# PRC-024-2 Gaps Whitepaper

## NERC Inverter-Based Resource Performance Task Force (IRPTF)

**Figure 1: PRC-024-2 Frequency Curve**

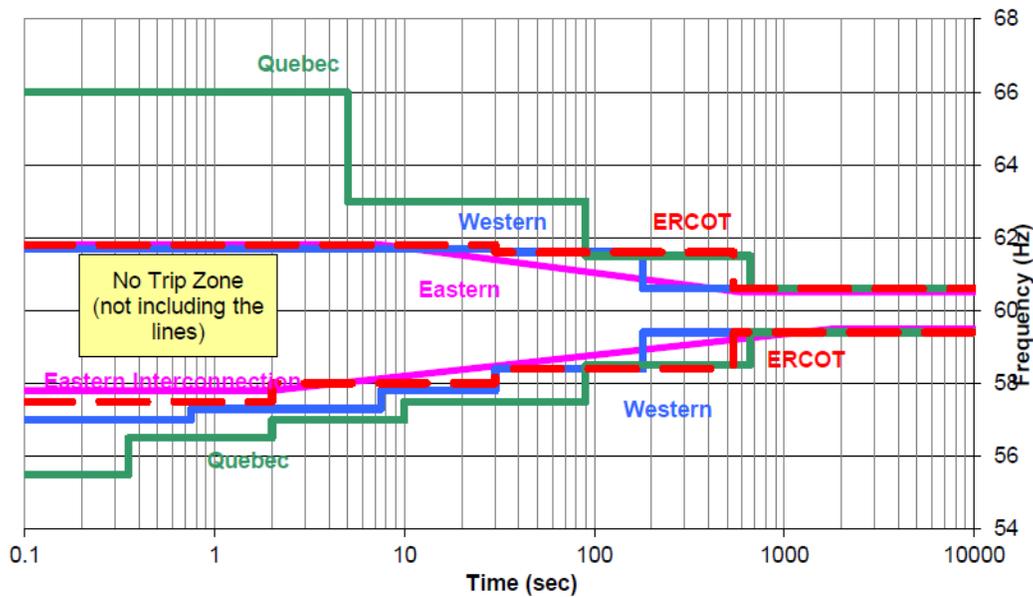
- There is inconsistency between the Curve Data Point tables and the Off Nominal Frequency Capability Curves as the table identifies “instantaneous” trip points while the time axis of the curve starts at 100 ms.

The task force that analyzed the Blue Cut Fire event found that, “[a] significant amount of solar PV resources disconnected due to a perceived system frequency below 57 Hz. This perceived frequency was due to the Phase Locked Loop logic indicating a near instantaneous frequency during the transient/distorted waveform period as less than 57 Hz. The solar development owner and inverter manufacturer interpreted outside of the PRC-024-2 no- trip curve area as a must-trip area. The frequency table in PRC-024-2 for the Western Interconnection indicates instantaneous trip for frequency equal to or

Further, the Off Nominal Frequency Capability Curve of PRC-024-2 is a logarithmic graph that starts at time  $t=0.1$  seconds. Thus, the Curve Data Point table “Instantaneous trip” value is inconsistent with the graphic.

Similarly, frequency trip settings for generation resources should be set as wide as possible while still ensuring equipment protection and personnel safety to support BPS reliability. This aligns with the intent of PRC- 024-2. One possible solution could be to change the requirement such that relay settings be set based on equipment limitations but no narrower than the “No-Trip” zones.

**Figure 2: PRC-024-2 Voltage Curve**

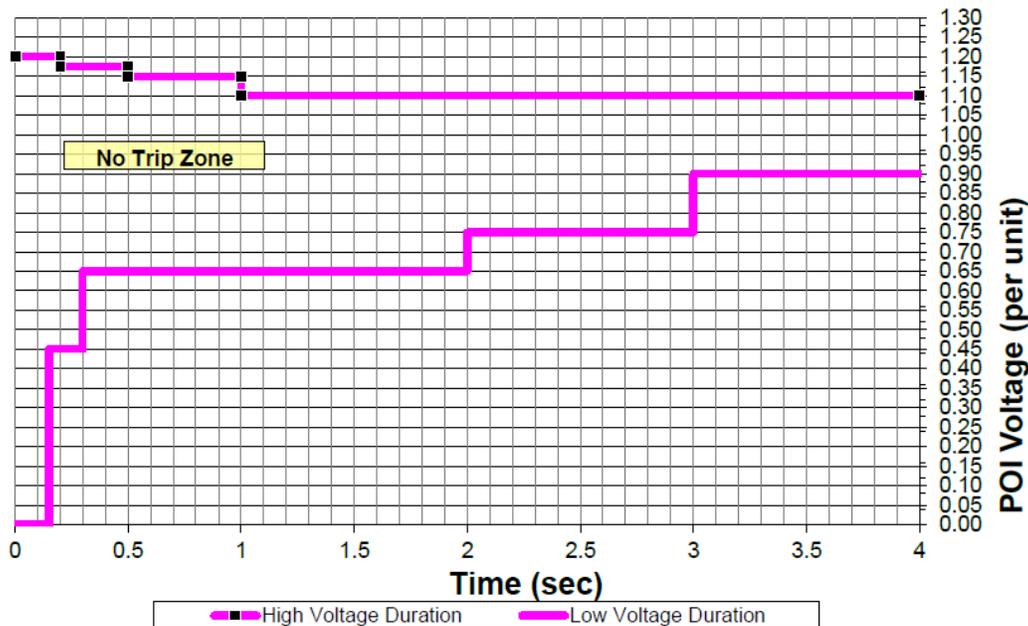
- The region outside the “No-Trip” zone of the PRC-024-2 curves should be clearly marked as a “May-Trip” zone so it is not interpreted as a “Must-Trip” zone. The preferred behavior is for the generators to remain connected and producing current during disturbances to the greatest extent possible.

PRC-024-2 specifies a “No-Trip” area for voltage and frequency excursions, as measured at the point of interconnection to the BES. According to the Blue Cut Fire Disturbance Analysis Report solar development owners and inverter manufacturers have misinterpreted the area outside of the “No-Trip” curve as a “Must-Trip” requirement. This is possibly due to the use of the term “instantaneous trip” in the tables following the voltage and frequency curves.

Point #5 in the Curve Details section of the “Voltage Curve Clarifications” of PRC-024-2 states, “voltages in the curve assume minimum fundamental frequency phase to ground or phase to phase voltage for the low duration curve and the greater of maximum RMS (Root Mean Square) or crest phase to phase voltage for the high voltage duration curve.”

Any voltage measured and compared with the PRC-024-2 voltage ride-through curve should be a well-filtered, fundamental frequency component of the voltage waveform. This filters out spurious voltage spikes caused by switching actions on the BPS. Voltage protective relays should not operate at the voltage levels specified in the voltage curve (e.g., 1.2 pu) using instantaneously sampled values, although it is reasonable for a generator resource to trip for instantaneous voltage spikes above equipment limitations if they can be properly detected. The other issue with this clarification is that the overvoltage component of the clarification states “the greater of maximum RMS or crest phase-to-phase voltage”. There is ambiguity and technical concern on how this is applied, and should be clarified.

Further, PRC-024-2 clarifies that the low voltage duration curve is based on either phase-to-ground or phase-to-phase voltage, the high voltage duration curve is only based on phase-to-phase voltage. It is not clear why phase-to-ground voltage should not also be considered for the high voltage curve. Without addressing these, there may be reliability issues, as identified in the Canyon 2 Fire Disturbance Analysis Report.

The PRC-024-2 voltage curve ends at four seconds, and the curve uses a cumulative time duration for the “No-Trip” zone. Protective relays must be set to accommodate the cumulative nature of curves. Under the current version of PRC-024-2, it is not clear at what points the cumulative values reset or what are the starting and ending criteria. This cumulative aspect is also applied in the Volts/Hertz relay protection that covers both synchronous generation resources and generator step up transformers and needs to have clarification for the action to trip or reset.

However, the intent of the PRC-024-2 voltage requirement is to define the minimum and maximum voltage conditions where generating resources may trip from protective relaying for voltage excursions. The region outside the “No-Trip” zone should be interpreted as a “May-Trip” zone and not a “Must-Trip” zone. Inverter settings should be determined based on equipment limitations and should be set to the greatest extent possible. This helps support bulk power system (BPS) reliability during and following grid events such as faults.
